CITY OF ALBUQUERQUE

Re: Certification Submittal for Final Building Certificate of Occupancy for
Advanced Health Care, [H-16 / D141]
2701 Richmond Drive NE
Engineer's Stamp Dated 12/16/08

**RE: Traffic Certification
Advanced Healthcare
2701 Richmond Drive NE**

**Re: Advanced Health Care Facility, 2701 Richmond Drive. NE,
(H-16/D141)
Approval of Permanent Certificate of Occupancy,
Engineer's Stamp Dated: 10-19-07
Certification dated 12-16-2008**

Re: Drainage Report for Advanced Health Care next to North Diversion Channel,
Engineer's Stamp Dated June 29, 2007, ZAP H-16

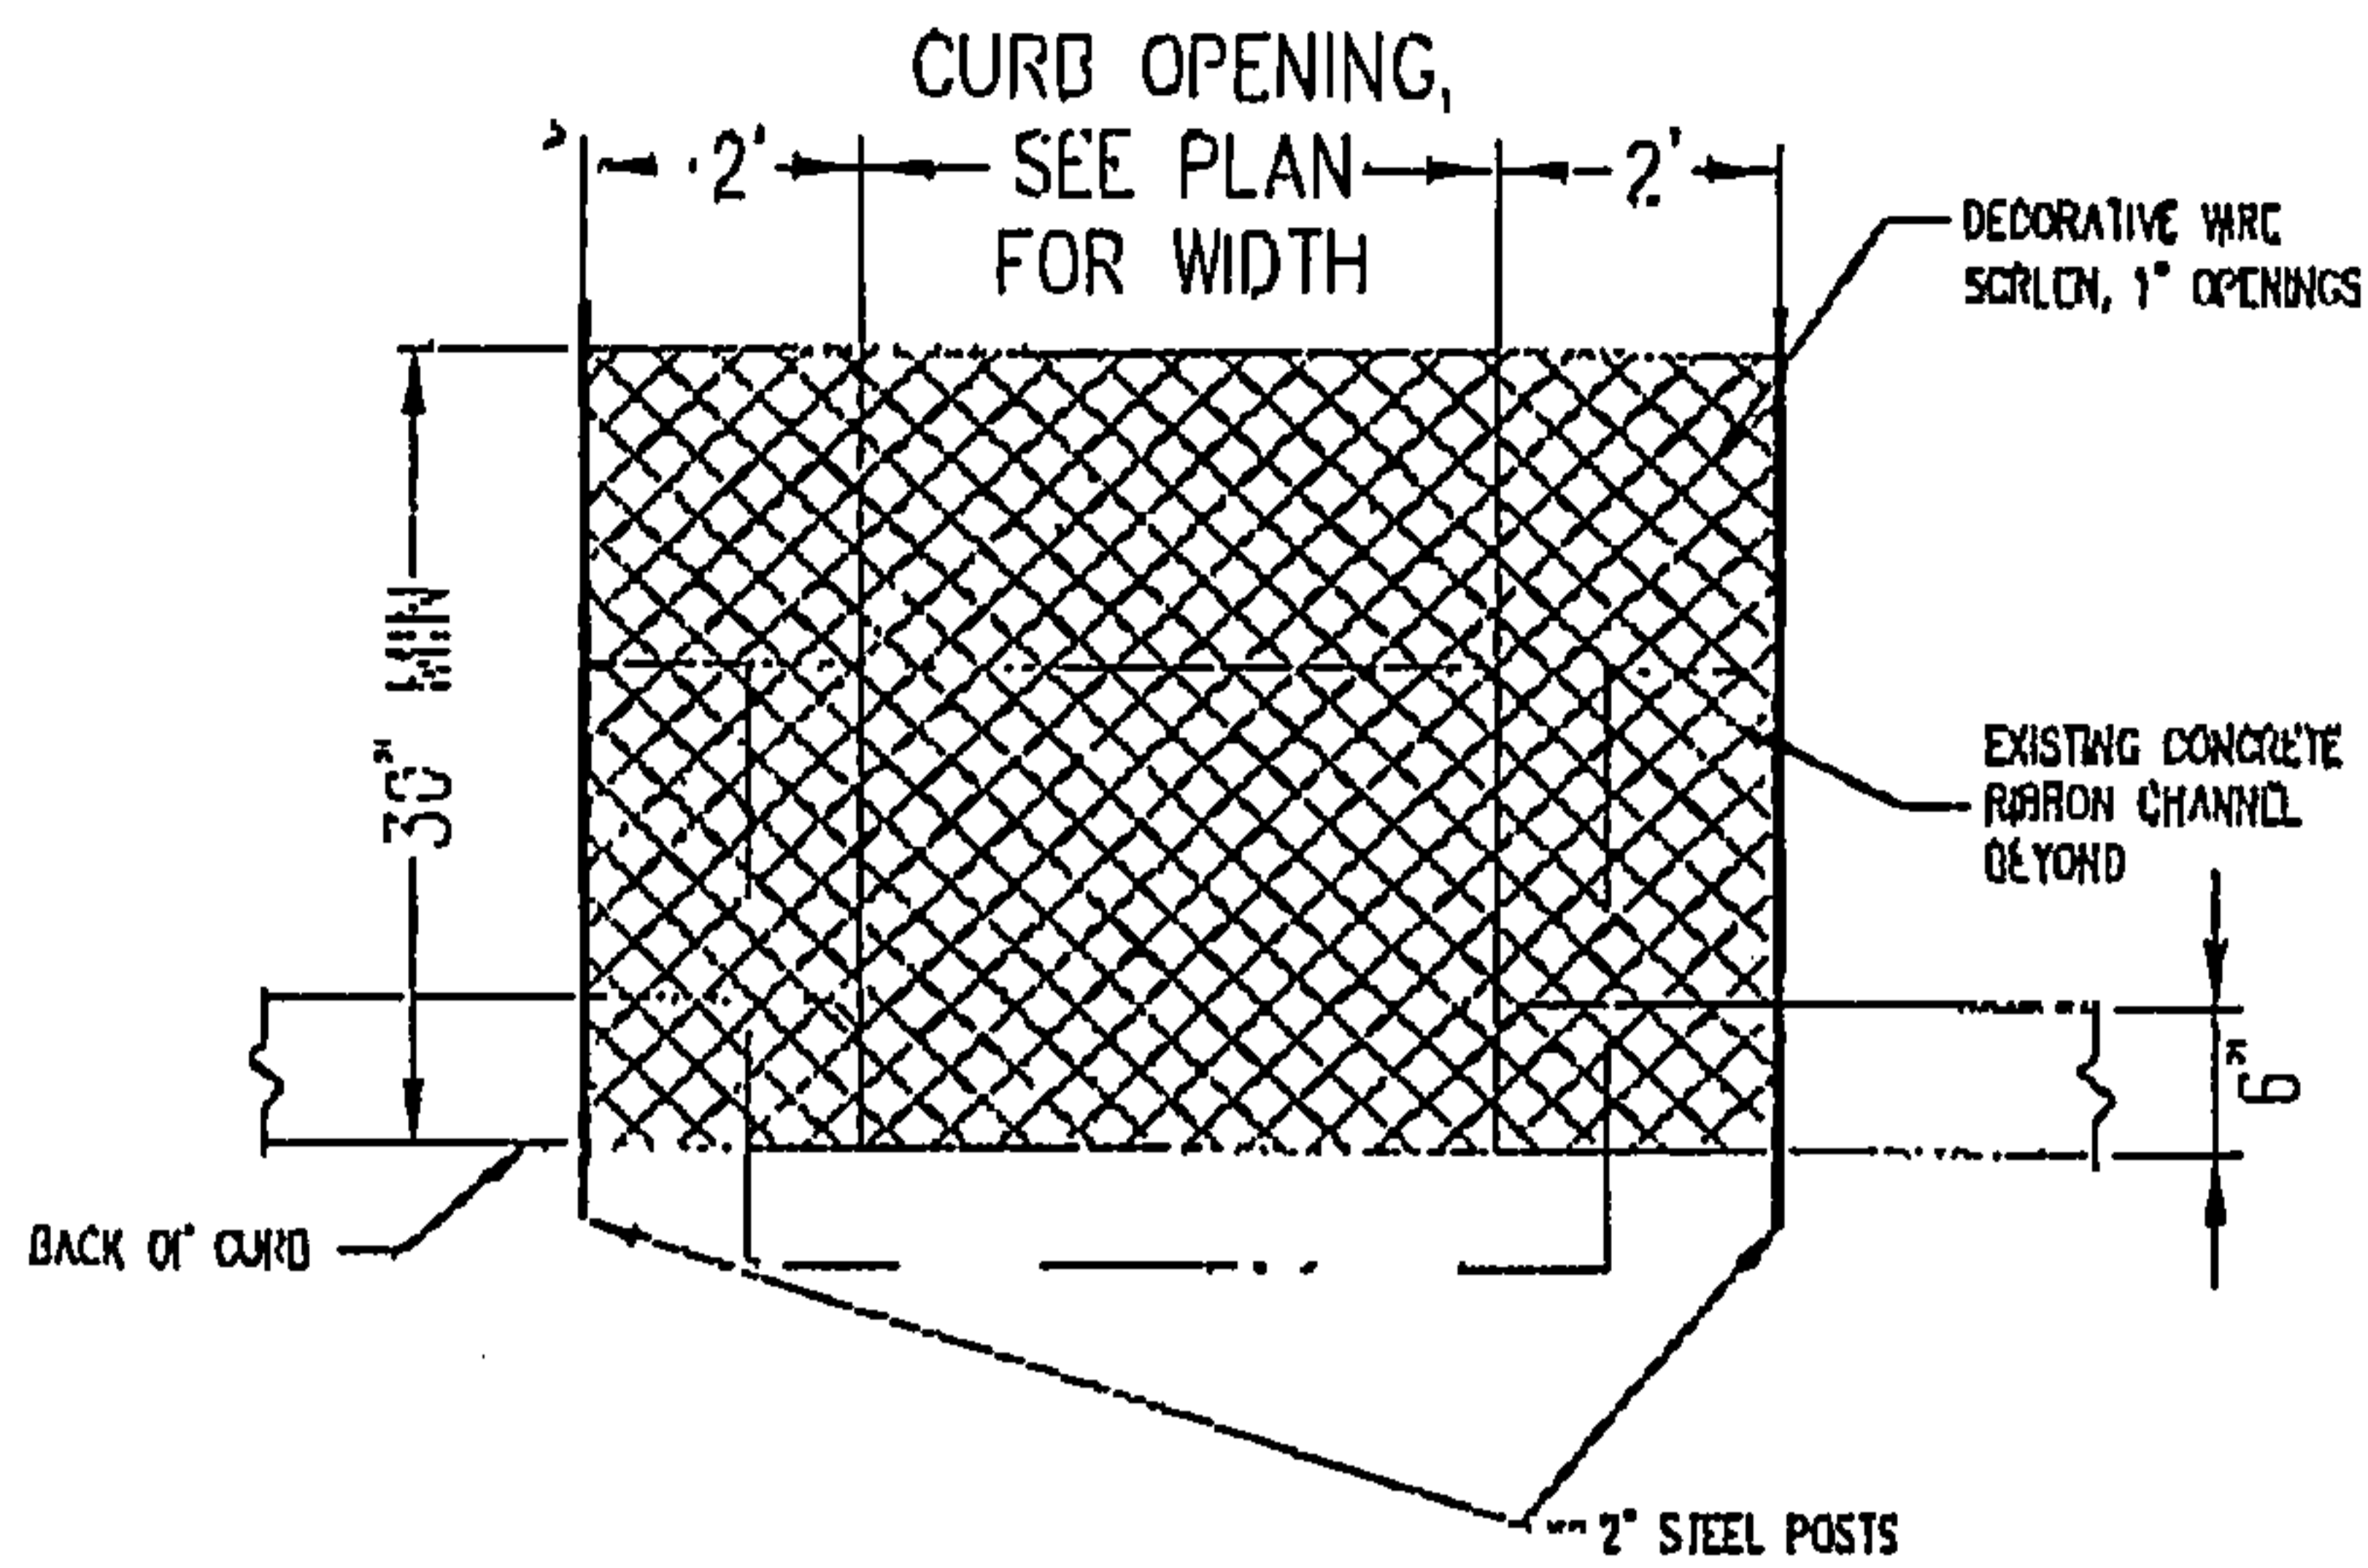
AMAFCA has reviewed the referenced report and site plan and approves the drainage concept. To comply with our EPA Stormwater Permit, we require some onsite water quality measures to keep floatable debris out of the North Diversion Channel (NDC). These can be wire mesh screens across the one-foot and three-foot channel connections to the rundown on the south side of the property. I have attached an example that has been used in other developments.

The AMAFCA Field Engineer said that AMAFCA does not maintain the rundown to the NDC. Do you know if the fifteen-foot Drainage Easement on the property was granted to a specific entity? If you have any questions, please call me at 884-2215.
